Hybrid Warning Message DTC P1CCC96 - Poor Ground Connection DC/DC Converter

Service Category Engine/Hybrid System

Section Hybrid/Battery Control System

Figure 1.

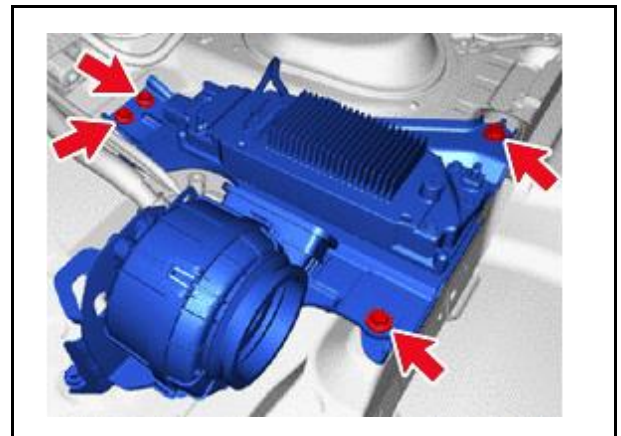
- B. Remove the four ground bolts and replace with the NEW updated bolts.

PART NUMBER		PART NAME	QTY
PREVIOUS	NEW		
90119-08D17	90119-A0383	Bolt	4
